Agenda Item No. 16.

Date: April 13, 2023
To: Mayor Kuhl and Council Members
From: Rebecca Markwick, Planning and Building Director
Subject: Bressack-Gantus Residence, 28 Walnut Avenue

It is recommended that the Town Council adopt Resolution No. 2300 (**Attachment 1**) approving Demolition and Design Review, for the subject project as described below.

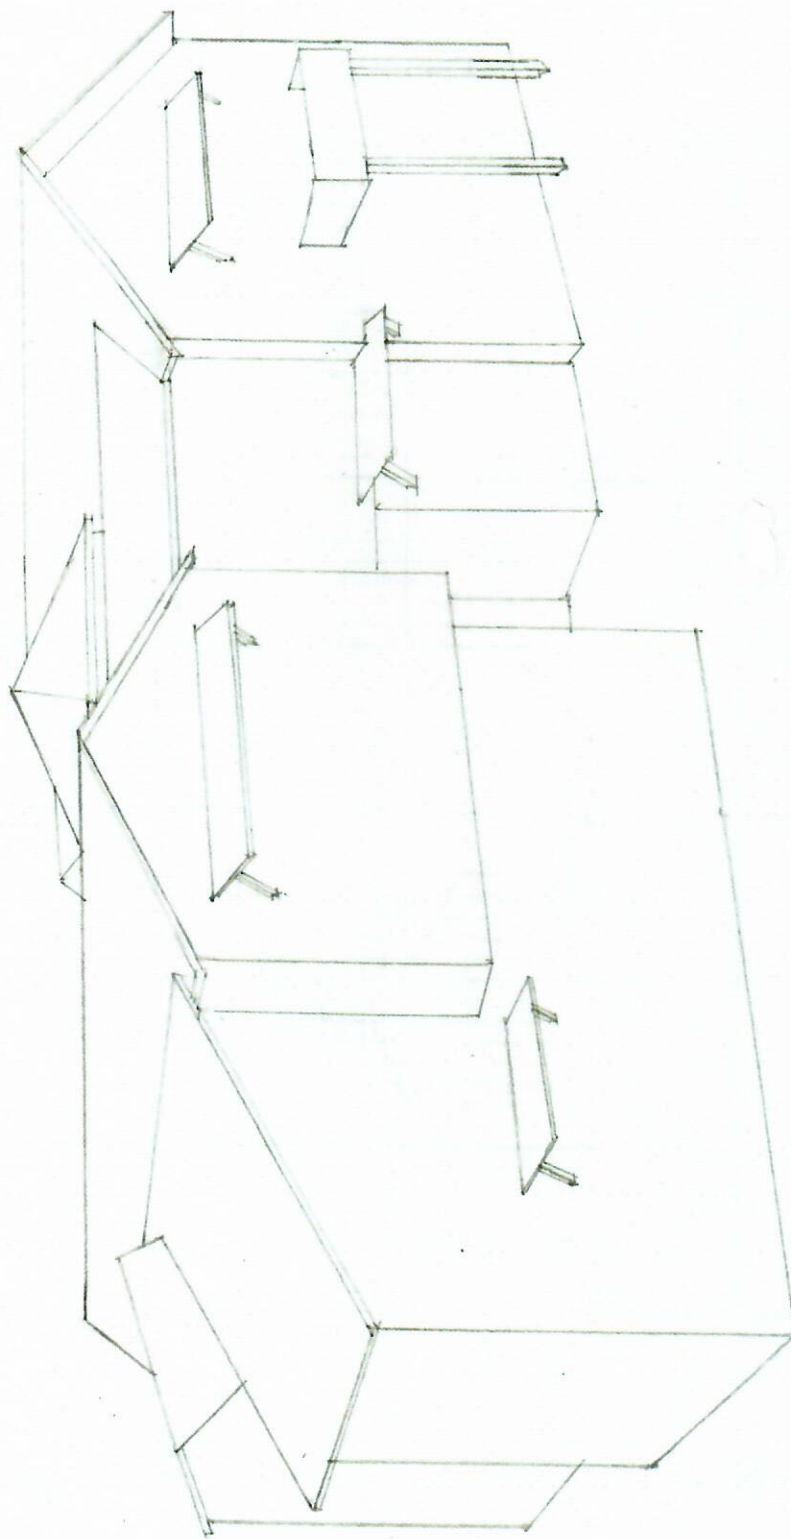
CHANGES (reflecting comments from previous ADR meeting)

- The concealing gate at the lower parking space is removed, since the neighbor clarified that she did not ask for it. Removing the gate facilitates general usage per ADR comment.
- The abandoned landscape water feature in the north west corner has been removed.
- The original focus on simplified, classic roof forms did not take into account the impact of the "big shoulder" on the west neighbor.

- The garage wing development has been divided into 3 volumes.
- The main ridge has been rotated 90°, sloping away from the west neighbor.
- The roof area (not over the garage) has been divided in two pieces:
 1. A cross gable over the wing pulled back just over 2 feet. That wing is now approximately 24ft away from the west neighbor's second floor, where 30ft would be standard side separation.
 2. A single pitch roof over the stair that slopes up relating to the intermediate landing, repeating the shape of the single pitch roof over the upper east side entry.

These changes reduce the mass of the garage structure roof. See attached drawing.

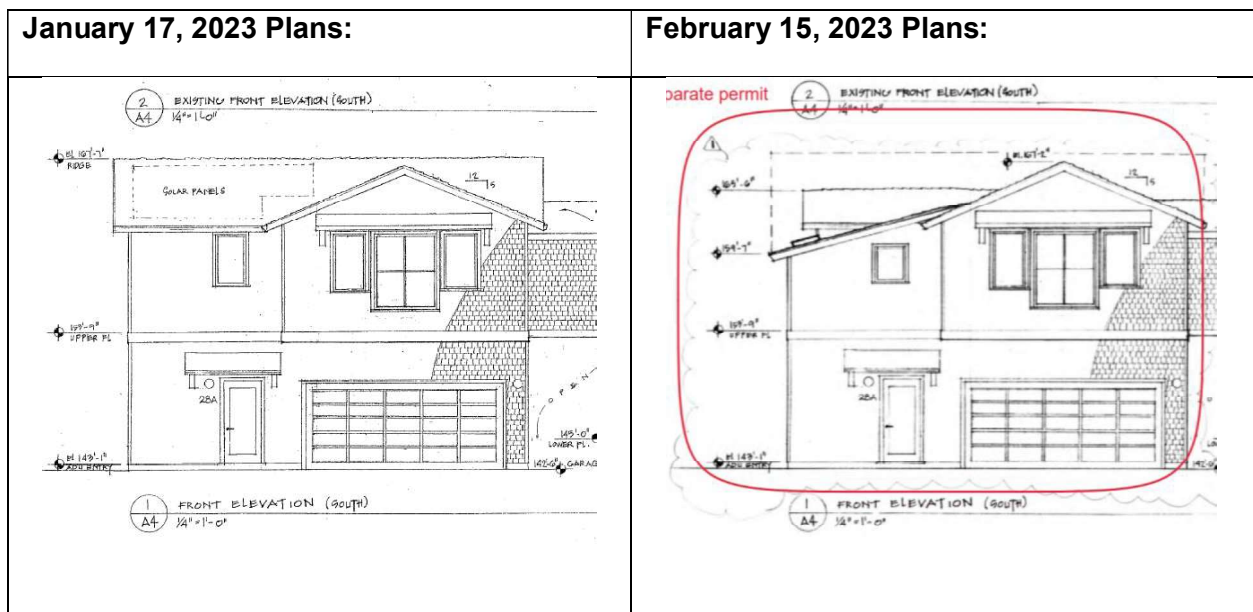
The draft minutes of the January 17, 2023 meeting, which are included in the agenda packet for tonight's meeting, show that this Group recommended significant changes to the Project:

- **Chair Kruttschnitt:**¹ Found that "the ADU should be diminutive to the house and garage, instead it exasperates the mass;" that the " main home seems secondary to the ADU;" and that the "[m]ass should step back with the slope."

- **Member Buckingham:** Noted that the ADU “looks monolithic in scale and almost commercial,” and recommended that the ADU be “stepped back” with a new design that will “push it back into the hillside.”
- **Member Dewar:** Agreed that “the massing of the ADU works against the design of the house and the topography of the site” and that development should be re-focused to the “space behind the garage.”
- **Member Fritz:** Observed that the “ADU has too much mass at the outside of the property” and “[w]ould like to see the ADU in a different location.”

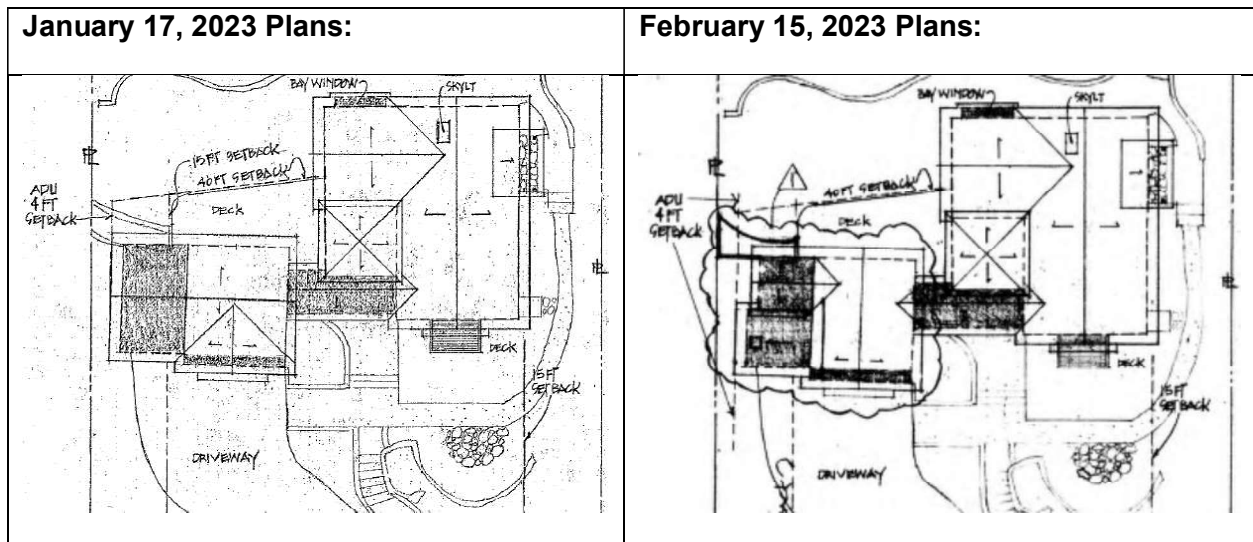
The “revised” plans indicate that the south-facing elevation of the ADU is still the exact same height. When viewed from the public right of way and other surrounding properties, the “revised” design will look identical, with the same bulk and massing. Furthermore, there have been no changes to the placement of the south-facing windows, which still violate design review requirements that forbid locating or designing new structures in a manner that intrudes upon the

privacy of neighbors. (Town Code, § 18.41.100, subd. (m).) As noted in our January 17 letter, these windows peer directly into private areas of adjoining properties.

The “revised” design also completely ignore this Group’s finding that the location of the ADU should be changed so that it is set back into the hillside to the north:

The “revised” plans show that the ADU is in the **exact** same location, with only minor, inconsequential articulation added on the west-facing elevation. There are no changes that address this Group’s findings regarding the massing, scale, and location of the ADU.
